AMENDMENTS TO THE DRAWINGS:

REMARKS

FIG. 5

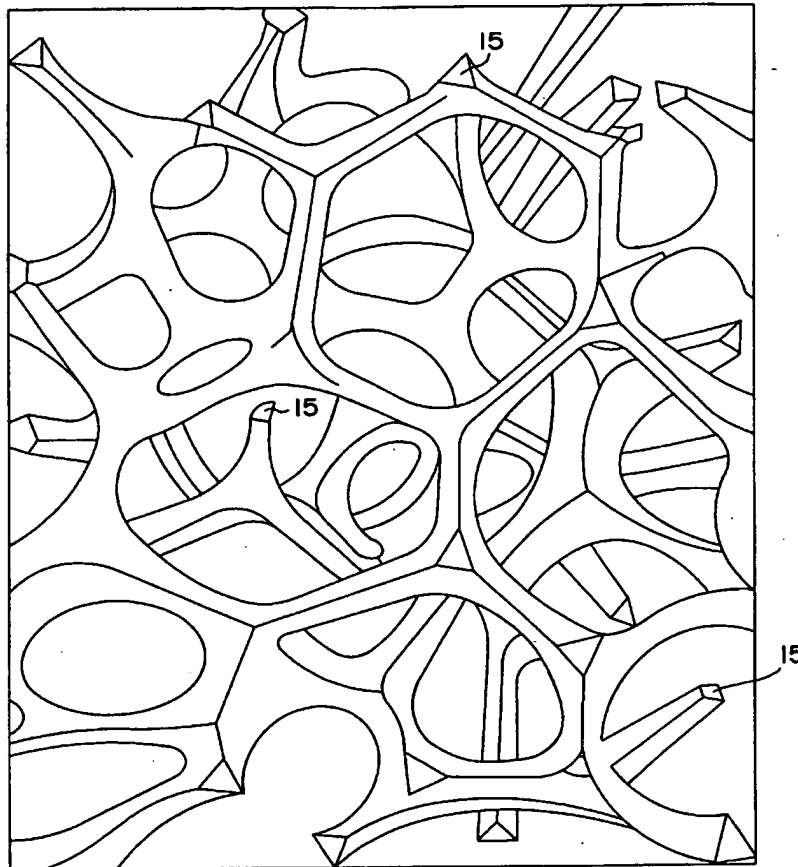
Claim 1, as amended, recites "said anodic chamber (1) and said cathodic chamber (10) each has an electrically conductive reticulated element (7, 206)." Jones fails to teach at least this element. The electrically conductive material in the fuel cell in Jones is the fluid flow plate 120. See Jones, Fig. 2-4 and col. 5, lines 32-45. In particular, Jones describes that "flow channels are typically formed on the face of the fluid flow plate by machining," and that "the flow channels [in the fluid flow plate] carry an appropriate reactant fluid." *Id.* at col. 5, lines 34-43. In contrast, the reticulated metallic element is described in the present specification as "electrically connecting the conductive bipolar plates 3 to the porous electrode 5 while simultaneously distributing the gaseous reactants." See Specification at 6, lines 2-5. As an example, the specification makes reference to reticulated materials "of the type described in U.S. Pat. No. 5,482,792." See specification at 6, lines 2-4. U.S. Pat. No. 5,842,792, in turn, describes a reticulated material as a tridimensional network of metal veins or wires. See Fig. 5 below.

One of ordinary skill in the art can readily appreciate from reading the specification that the reticulated material in the claimed invention is not the conductive material in Jones. Nothing in Jones discloses such a "reticulated element" as recited in independent claim 1. Therefore, Jones does not anticipate claim 1 and all claims dependent therefrom. Applicants request the rejections withdrawn.
